November 24, 2010

RE: Response to NMED's "Approval With Modifications
Revised Railroad Rack Lagoon Overflow Ditch and Fan-out Area, SWMU No. 8 Subsurface
Investigation Final Report
Western Refining Company Southwest Inc., Gallup Refinery
EPA ID # NMD000333211 HWB-WRG-10-002"

FIGURE 2

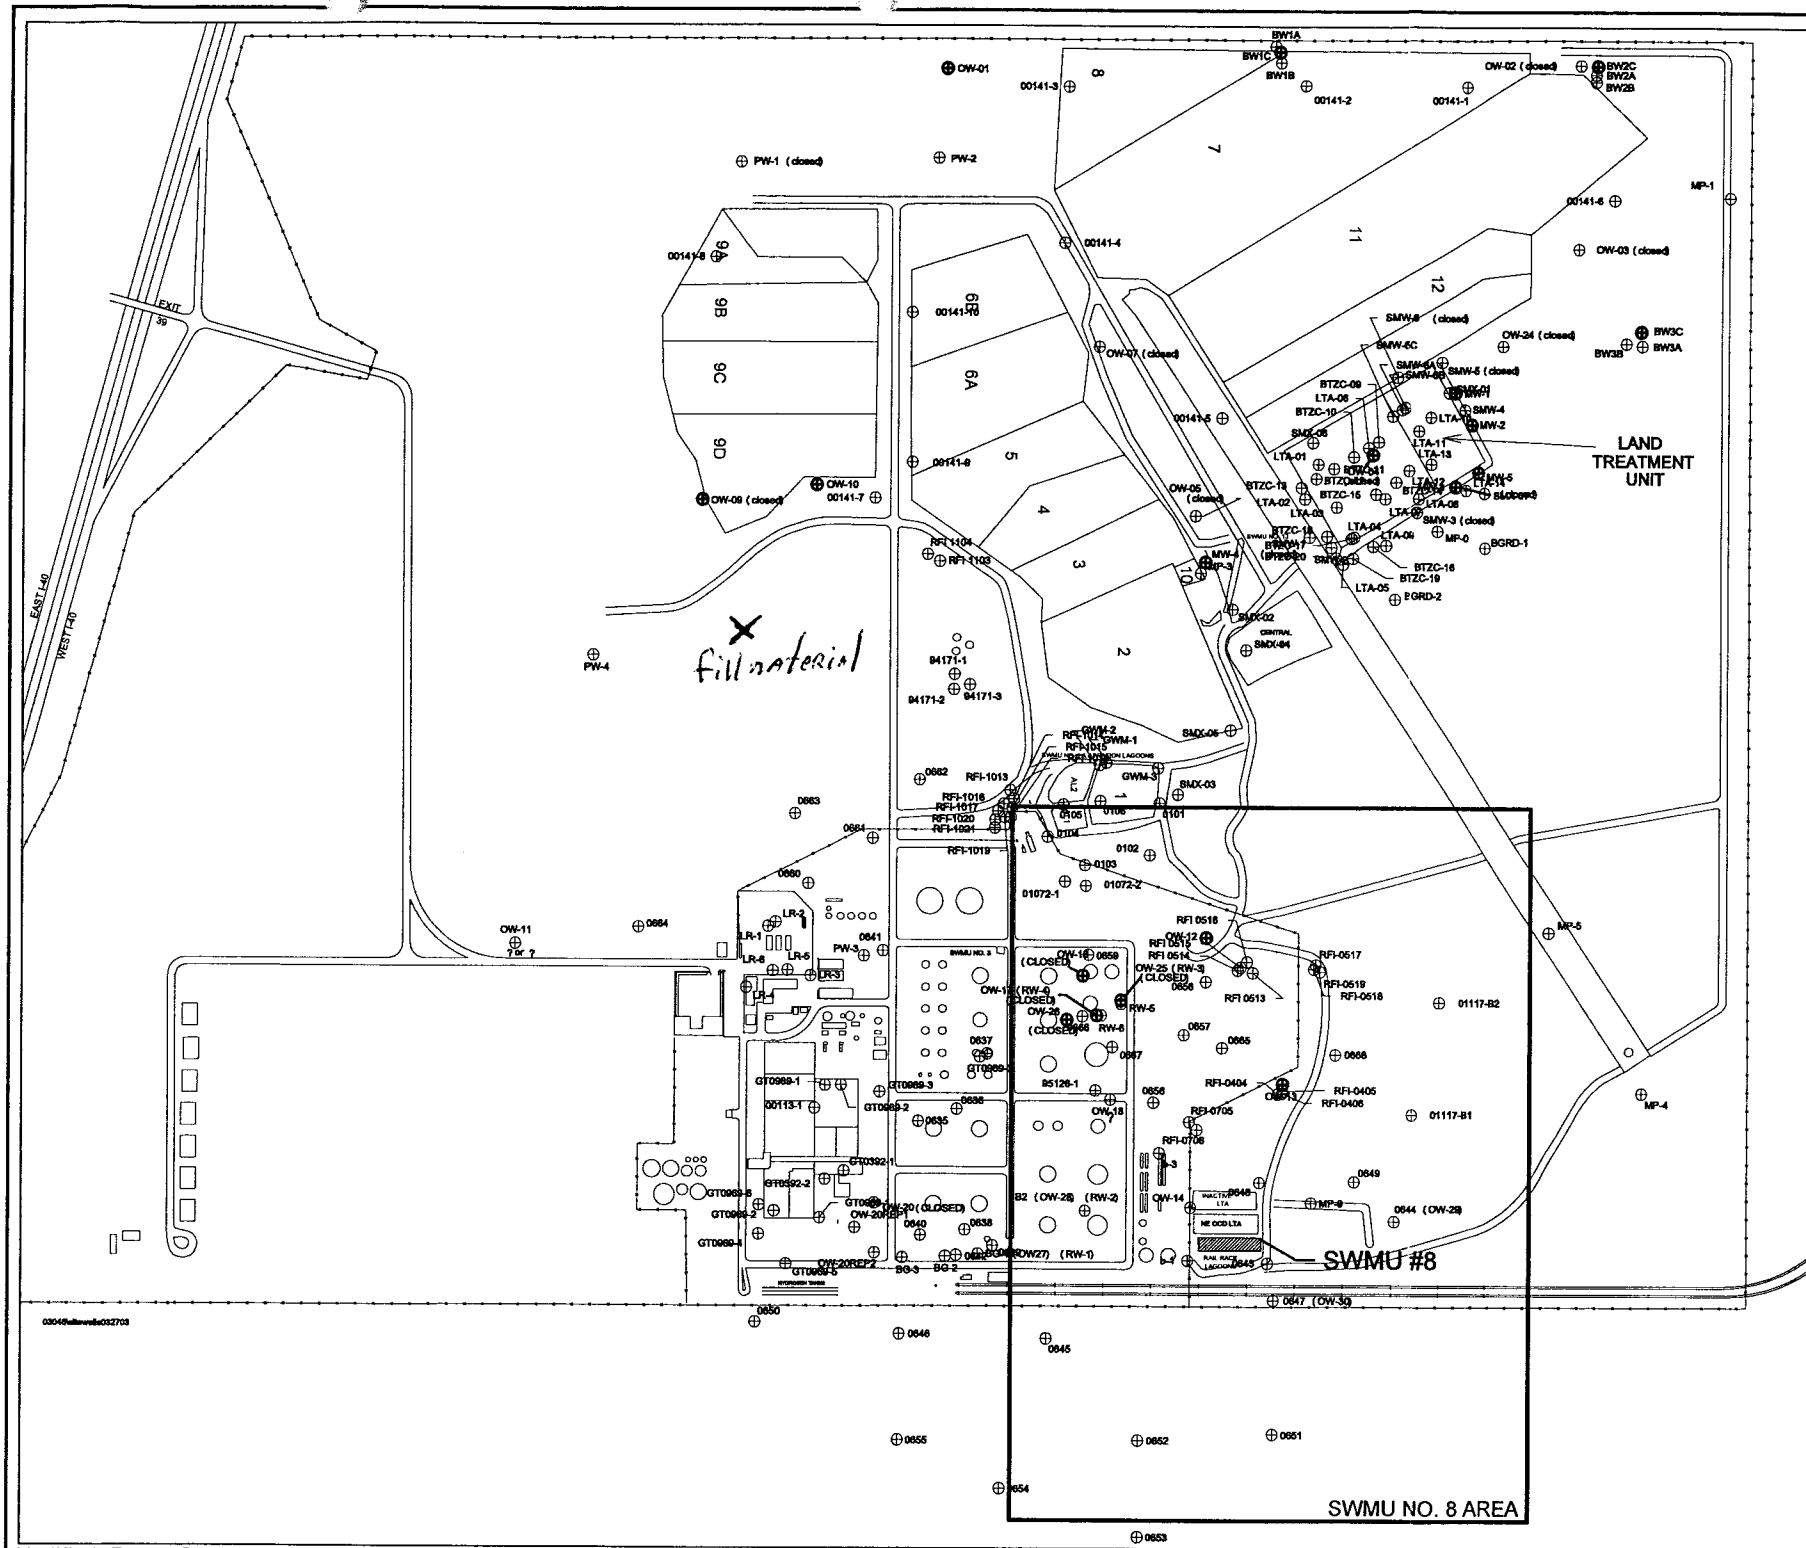
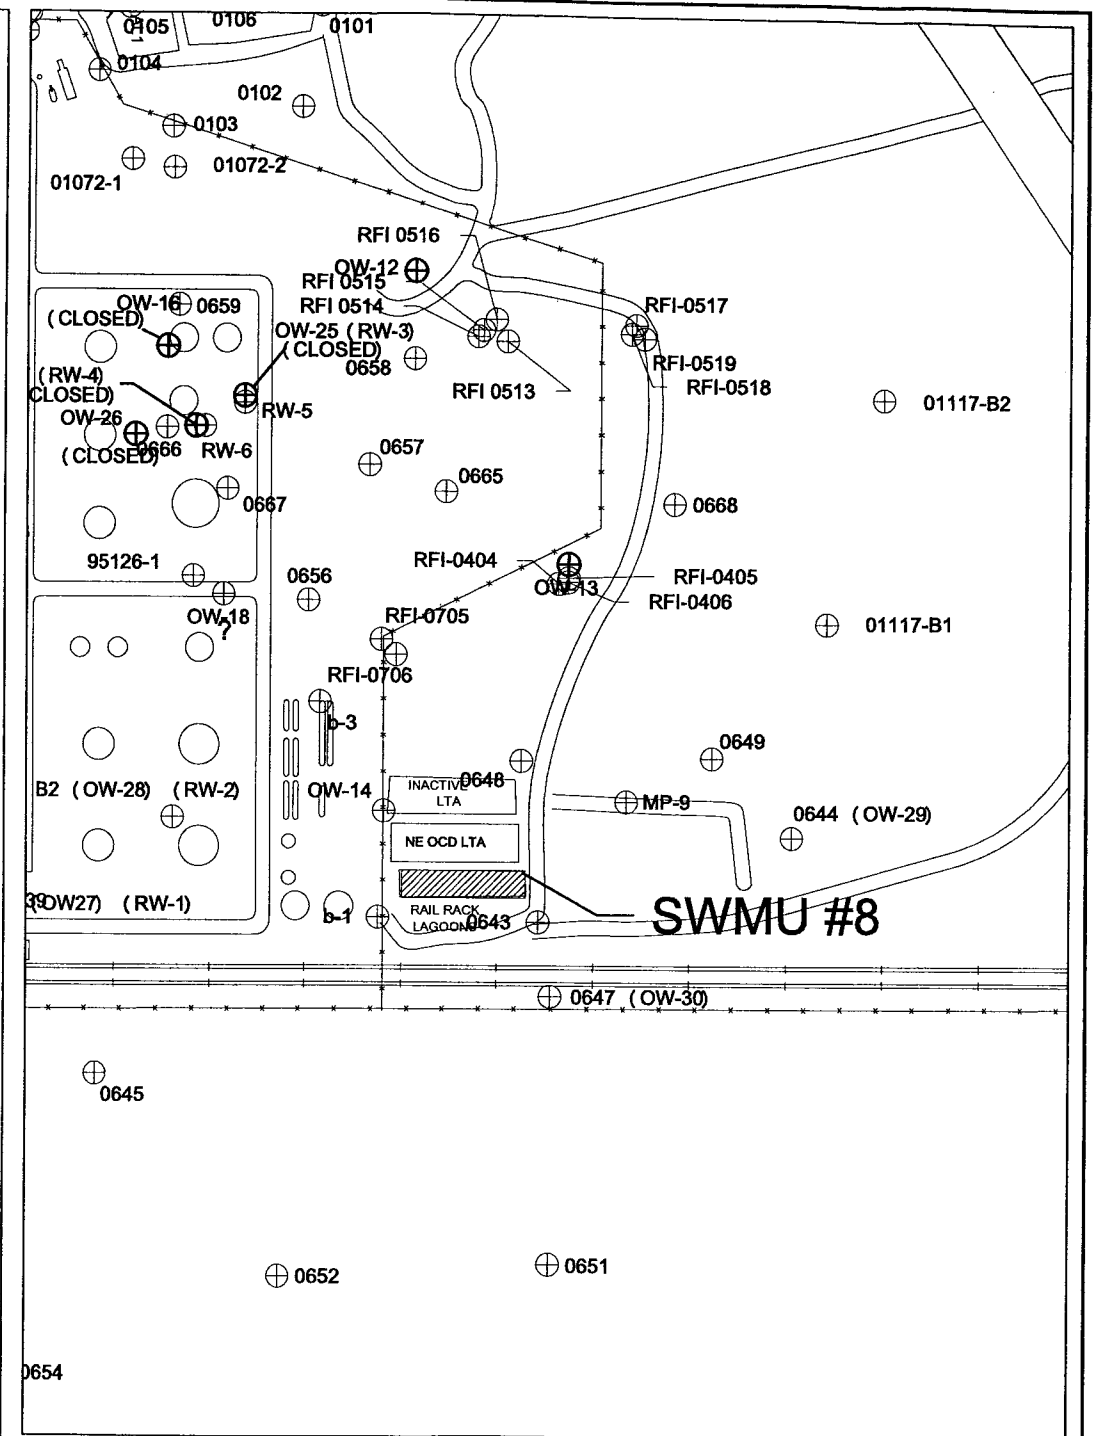
In Section 7.0 (Conclusions), page 7-1, paragraph 4, the permittee states "[t]he excavations currently remain open as Gallup is awaiting NMED's approval of this report prior to backfilling the excavations with clean backfill material." The permittee does not state from where the clean backfill material will be obtained. The permittee must identify in a response letter the source of the clean backfill and provide analytical data that demonstrates that the fill is clean if the material is obtained from within the refinery.

The clean backfill material will come from a virgin hillside east of Pond 9 as shown on the attached map (Figure 2) with a red X. To our knowledge there has never been any refinery related activities in this area. The bottom of the hillside which has been excavated for other fill activities was divided into 4 sections and a composite of three samples was taken from each section. The entire length of the excavation is approximately 170 feet in length. All four sample result constituents came back non detect (ND) for EPA Method 8270C semivolatiles, Method 8260B volatiles and Method 418.1 TPH. The Hall Analysis Lab Report dated November 22, 2010 is attached.
